Project Name: Courtice Mixed Use Seniors Development at 1697 Highway # 2 in Courtice, ON

Addendum No. 4

Project No.: 21046
Date: October 23, 2024
Project: **Courtice Mixed Use Seniors Development at 1697 Highway # 2
RH GAY HOLDINGS COMPANY**

The following information supplements and/or supersedes the bid documents issued on September 10 2024

R1

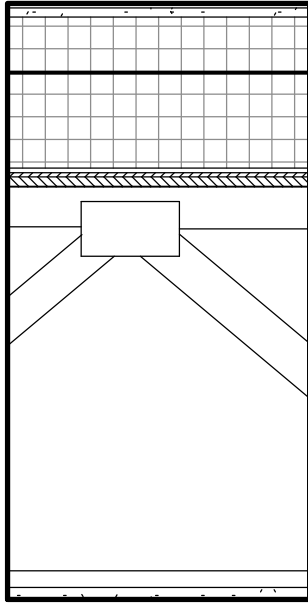
4 .6 **Question:** **Are you looking a continuous insulation layer of R25 minimum or 150mm insulation thickness for base layer? Minimum R25 will be two (2) layers of 2.2" PolyISO or one layer of 4.4" PolyISO Or 150mm insulation will be equal to R35 that two (2) layers of 3" PolyISO**

4.7 **Question:** Are you looking 1% or 2% full tapered insulation over the base layer of PolyISO?

4.8 **Question:** Does this still need a 13mm cover board / production board over the tapered insulation at roof type R1 and R2?

4.9 **Question:** Does this need a 13mm underlayment board at roof type R1 and R2?-

Answer: R35 continuous insulation (base layer) is required. Refer to BBA Sketch SK01dated October 23, 2024.

Answer: 2% full tapered insulation.

Answer: Required on both R1 and R2.

Answer: Pending manufacturer approved system, underlayment board is likely not required on a plywood roof deck, assuming all seams will be taped and smooth- provide shop drawings for approved system. The underlayment board is required on R3, where a steel deck is provided. R3 also requires a self adhered Air vapour barrier on top of the underlayment board and 100-200mm tapered insulation.

ROOF TYPE 1 (1HR FRR)
 Thermoplastic Polyolefin (TPO) ROOFING
 13mm Protection Board
 150mm (R35) base layer Poly-iso Insulation
 Top Layer Tapered Insulation at 2% Slope
 Self Adhered Air Vapour Barrier
 19mm Plywood Sheathing
 Wood truss
 22mm Resilient Metal Channel 400mm O.C.
 16mm Type C Gypsum Board
